Minor subdivision to subdivide the existing single-family residential lot into two (2) single-family residential lots. A variance will be required because proposed Lot 1.02 does not front on a public street (Tennis Court Lane) improved to meet municipal requirements.

**Re: TagCap Atlantic 50 Rumson, LLC
Minor Subdivision Plan
50 Rumson Road (CR 520); Block 103 Lot 1, R-2 Zone
Completeness Review, Engineering Review and Fee Determination**

1. Minor Subdivision Plan for 50 Rumson Road, Block 103, Lot 1, prepared by Patrick R. Ward, PE, PP of Insite Engineering, dated August 19, 2025, consisting of twelve (12) sheets.

<u>DRAWING TITLE:</u>
MINOR SUBDIVISION PLAN
<u>SHEET TITLE:</u>
EXISTING CONDITIONS & TREE REMOVAL PLAN
<u>SHEET NO.:</u>
C200

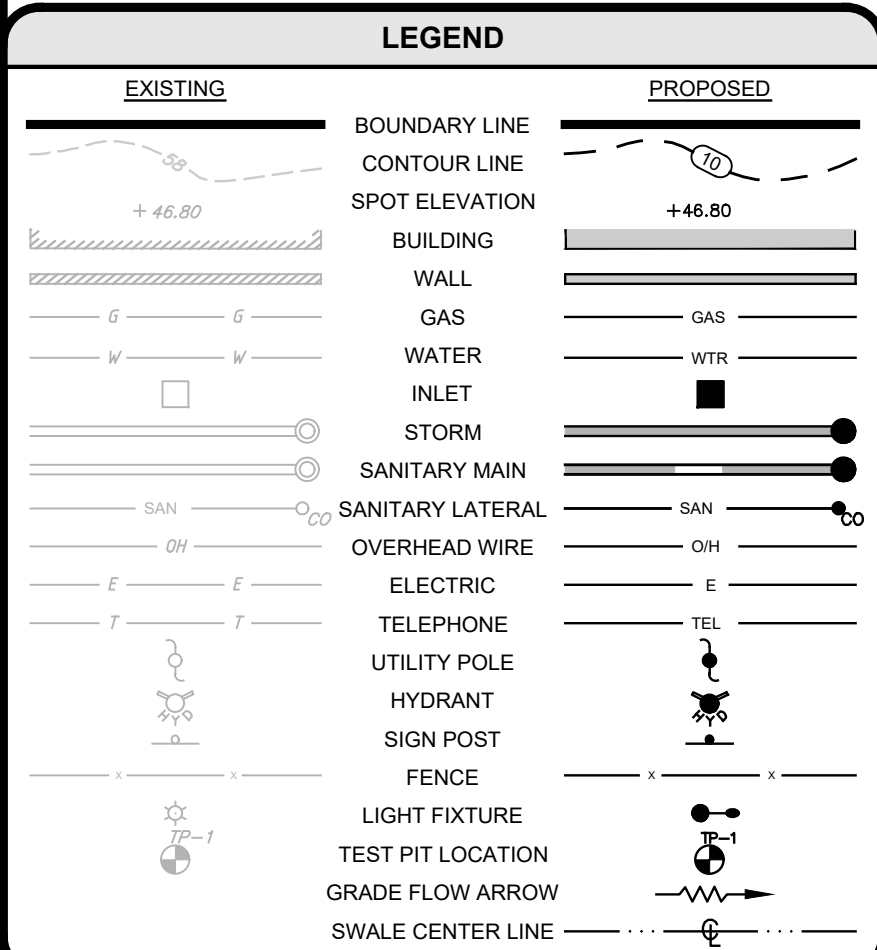
- 6.1 The survey and landscaping plans do not adequately demonstrate compliance with Ordinance §16-1.4 – Prohibited Activities. The survey shall be updated to identify tree species. The plans shall identify compliance with the following subsections:

- 6.2 The site contains seventy-eight (78) existing onsite trees, thirty-eight (38) of which are proposed to be removed. Replacement trees are proposed. The plan shall be revised to demonstrate compliance with the tree replacement requirements of Ordinance §16-1.8.

- a. Radius;
 - b. Arc length;
 - c. Central angle;
 - d. Chord bearing & length.
 - e. Incorporate into the deed of dedication noted in comment 1 above.
3. An existing brick wall indicated on the Existing Conditions & Tree Removal Plan, sheet C200 was not indicated on the Development Plan. Per sheet C200, the wall's location would fall within the boundary of the proposed dedication. Relocate the wall or provide an indemnification agreement to the County for potential damage to or damage caused by the location of the wall within the right-of-way.

**GRADING & UTILITIES
PLAN**

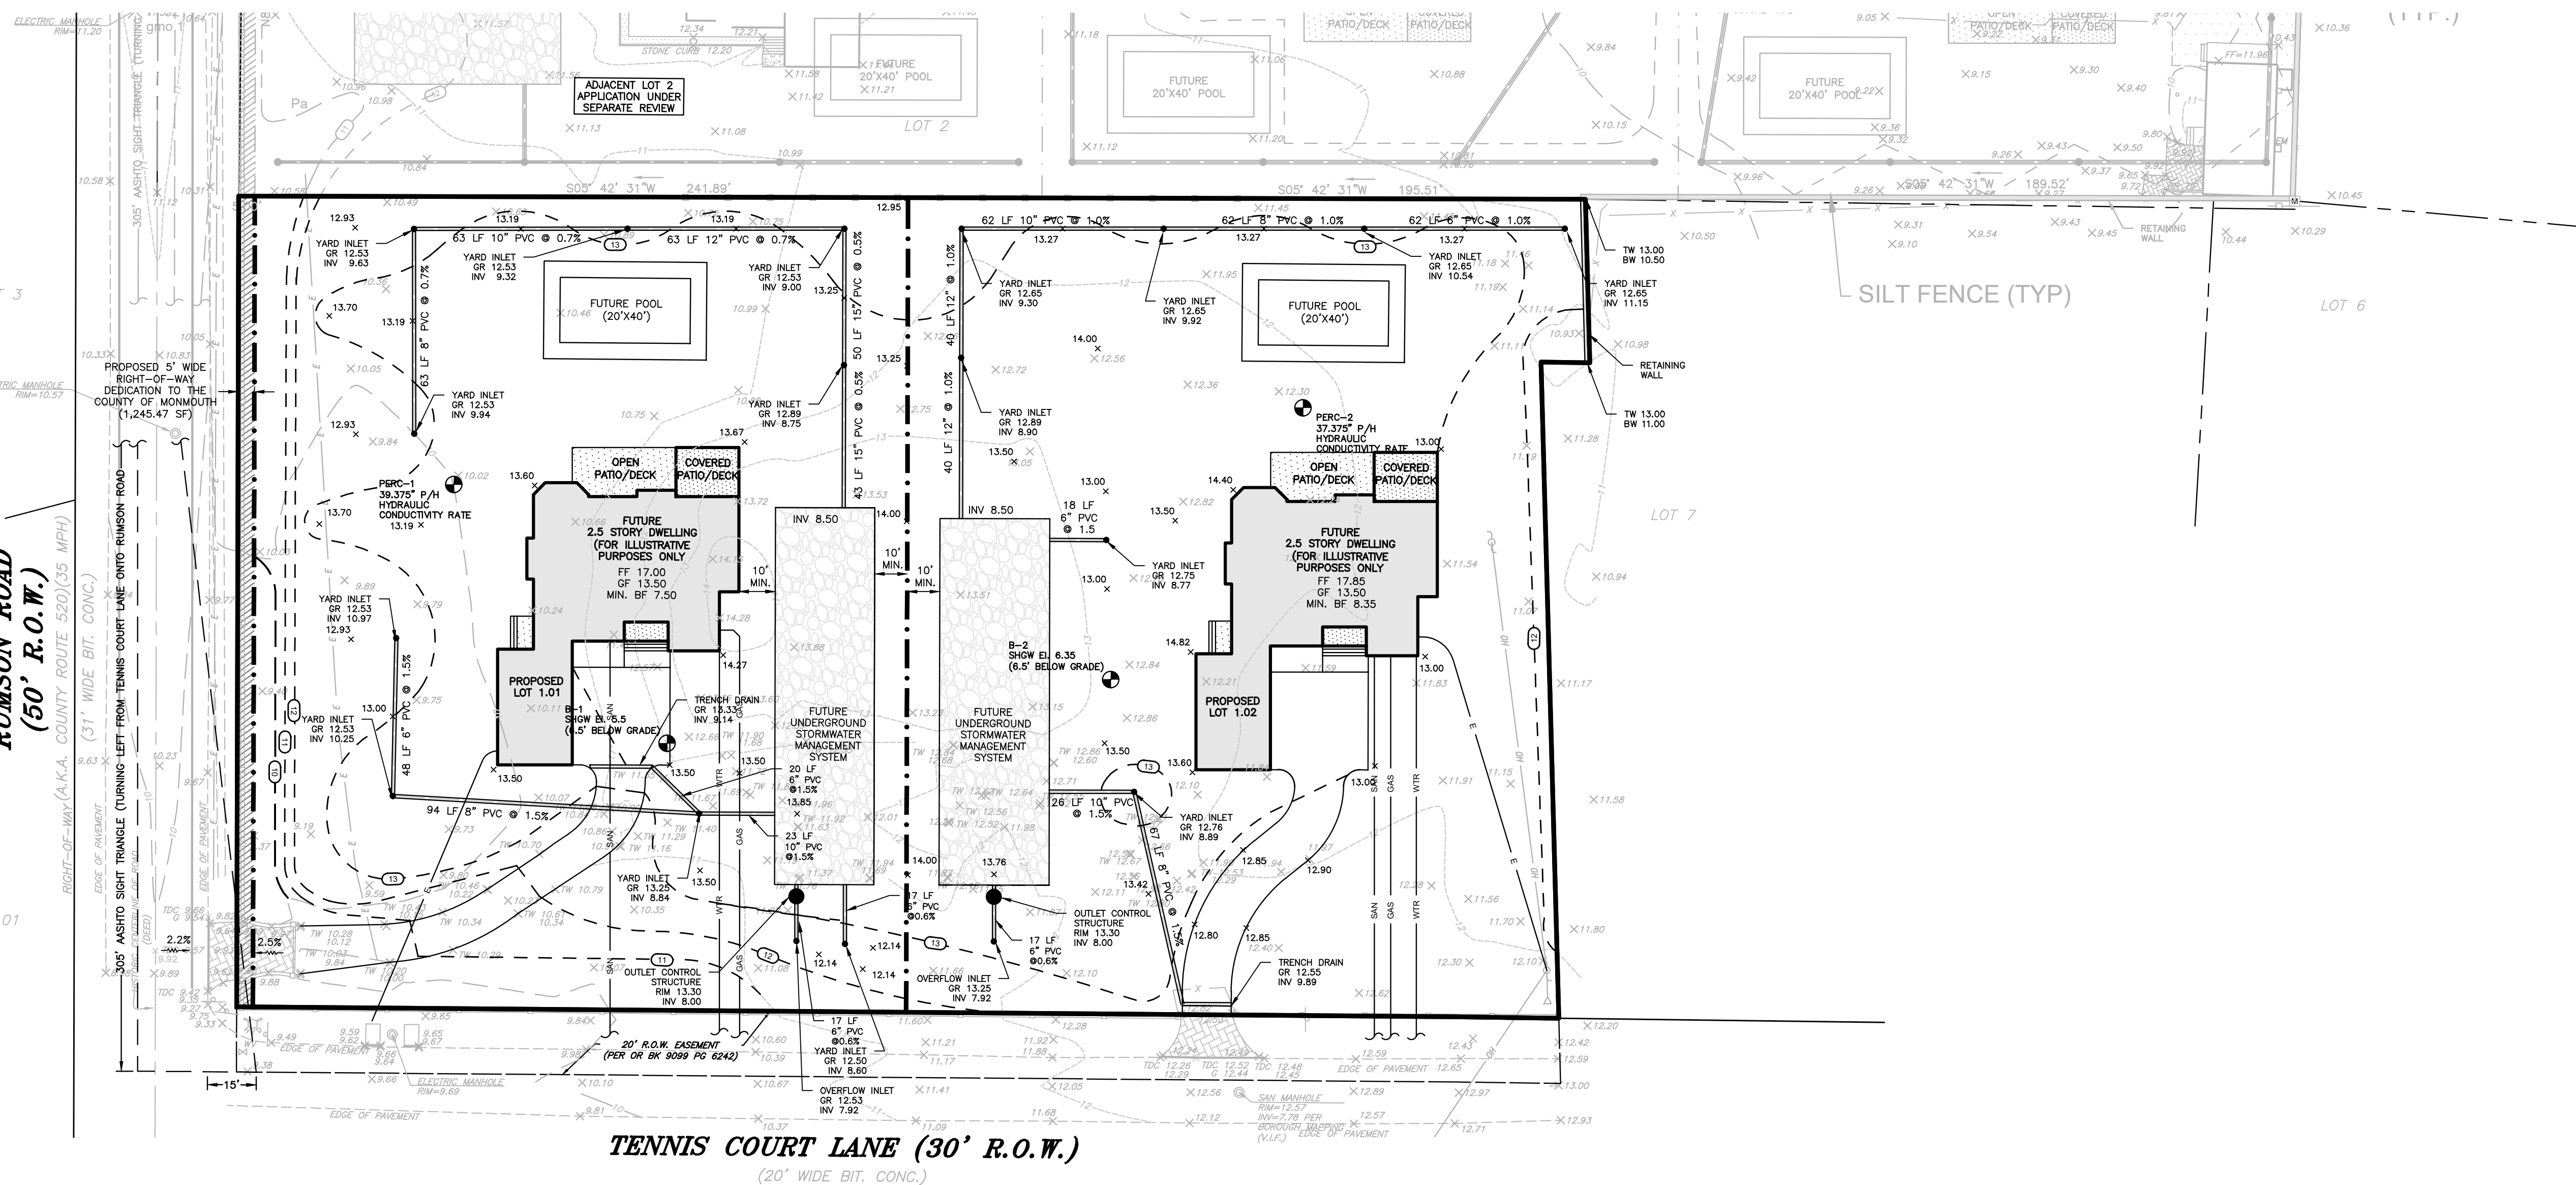
- Pipe calculations and the inlet drainage area map.
 - The dimensions of each underground detention basins.
 - Outlet control structures for review.
- 4.11 Ordinance §22-7.39 – Basements/Cellars, requires that the floor slab of a basement or cellar, as well as, the bottom of the sump pit to be a minimum of two (2) feet above the seasonal high water table (SHWT). Soil borings have been conducted and the basement elevations are proposed a minimum of two feet above the measured SHWT elevation. As the SHWT measurements resulted in two different elevations, we would recommend utilizing the conservative test result of EL 6.35 for both dwellings' minimum basement elevation.

- 4.12 Review grate elevations of the overflow inlets and the yard inlets. The overflow inlet grate on Lot 1.02 is proposed higher elevation than the yard inlets.

48" CHAIN LINK FENCE
NTS

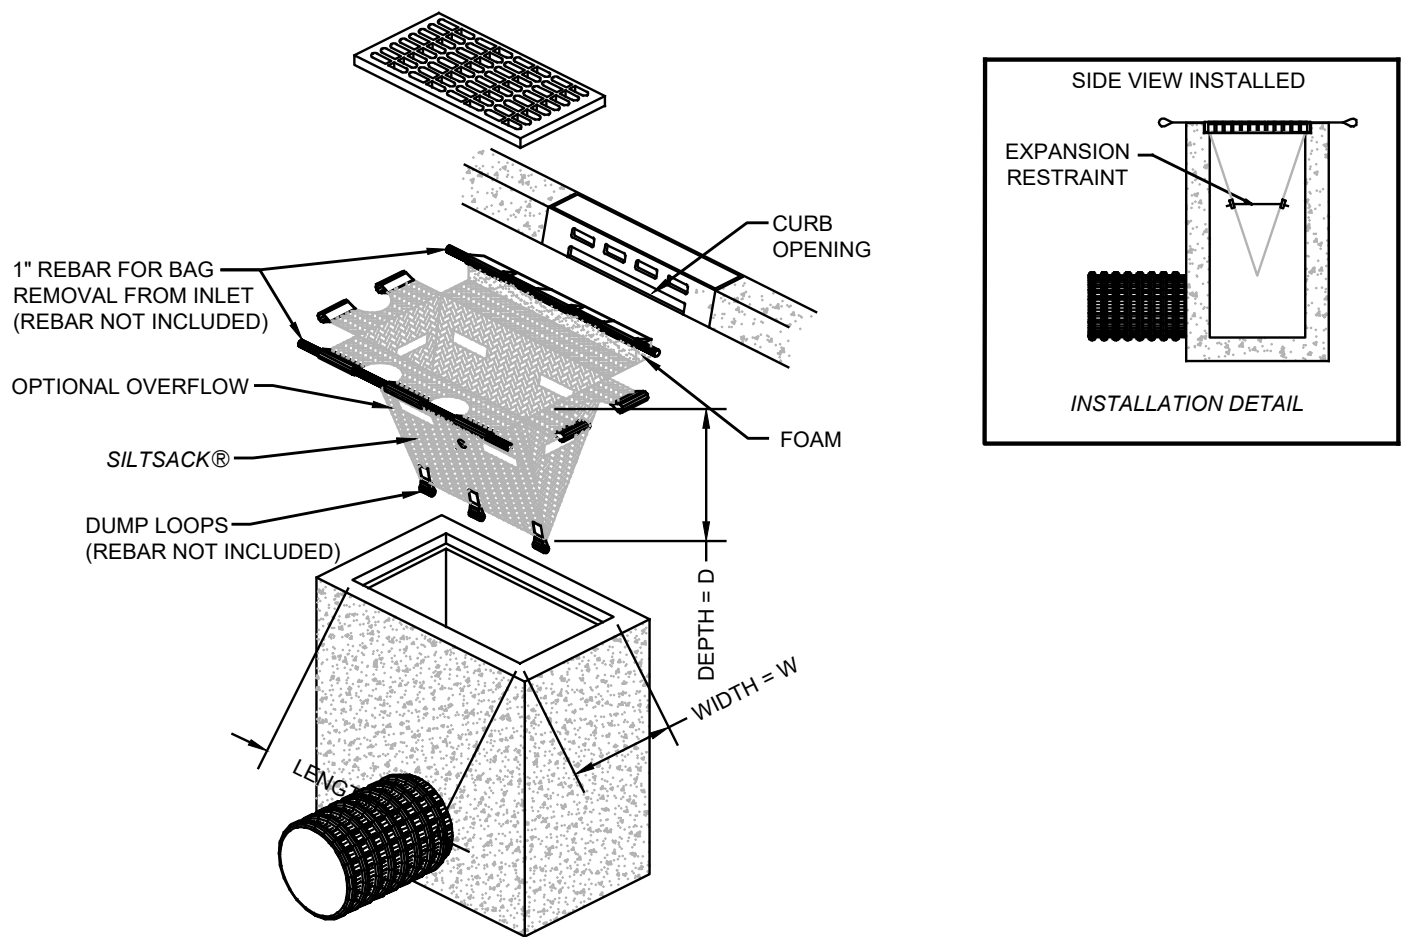
- 3.1 Revise the plans to clarify bedroom count of the dwellings and if the parking requirement of Ordinance §22-9.2.b.1(b), Exhibit 9-1 will be met.
- 3.2 A detail has been provided for a 48" tall aluminum fence. Revise the plan to clarify where this is proposed.
- 3.3 The applicant should provide testimony on the available sight distance at each proposed driveway, including due to existing/proposed landscaping.
- 3.4 We defer to the Borough Fire Official for further review of the application with respect to emergency vehicle access and maneuvering.
